HISTORIC AND DESIGN REVIEW COMMISSION

HDRC CASE NO: 2018-496
ADDRESS: 122 HEIMAN
LEGAL DESCRIPTION: NCB 679 BLK 1 LOT 38 STAYBRIDGE HOTEL
ZONING: D, HE
CITY COUNCIL DIST.: 2
DISTRICT: St. Paul Square Historic District
LANDMARK: Heimann Bldg / Southern Pacific
APPLICANT: Richard Hope/RC Hope Group, LLC
OWNER: East Commerce Realy, LLC
TYPE OF WORK: Construction of an exterior egress stair, fenestration modifications
APPLICATION RECEIVED: September 19, 2018
60-DAY REVIEW: November 18, 2018
REQUEST:

The applicant is requesting a Certificate of Appropriateness for approval to construct an exterior stair on the west façade from the third story to the ground level. This addition will require the modification of an existing window opening into a door opening with a transom window.

1 WEST ELEVATION
SCALE: 1/8"=1'-0"

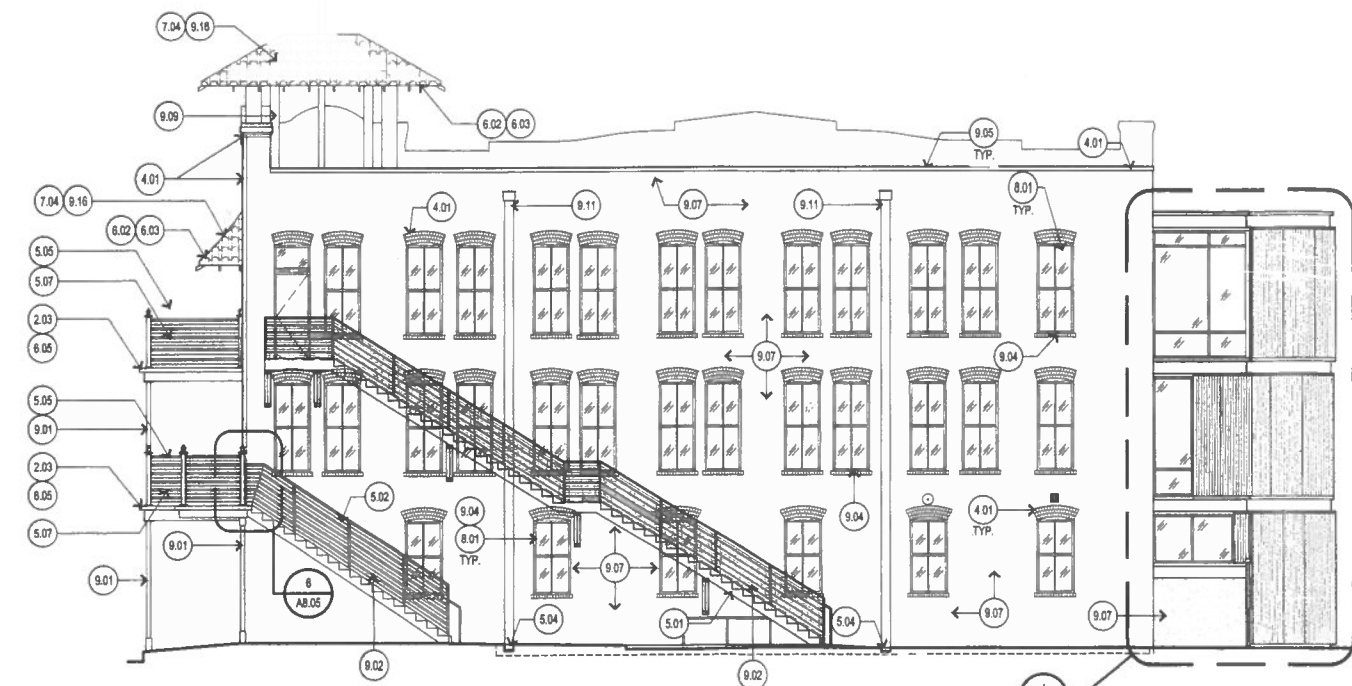
- b. **STAIRCASE ADDITION** – On the west façade, the applicant has proposed to install a staircase for egress that will lead from an existing third floor window opening to the street level below. The installation of this staircase would also require the removal of an existing window and the installation of a door. The applicant has noted that the door that will be installed is a door that is original to the building. The applicant has also noted that the existing opening will not be modified and that the transom window detail found on the front façade will be replication in this opening. Generally, staff finds this approach appropriate.

- c. **STAIRCASE ADDITION** – The applicant has proposed for the staircase to be approximately 5 ½" removed from

the historic structure and be supported by brackets that are anchored into the historic structure. Staff finds the proposed distance away from the historic structure appropriate; however, staff finds that the applicant should revise the proposed staircase to feature a structural system that does not require penetrations into the historic façade.

Staff recommends approval based on findings a through c with the stipulation that the applicant revise the proposed staircase to feature a structural system that does not require penetrations into the historic façade.
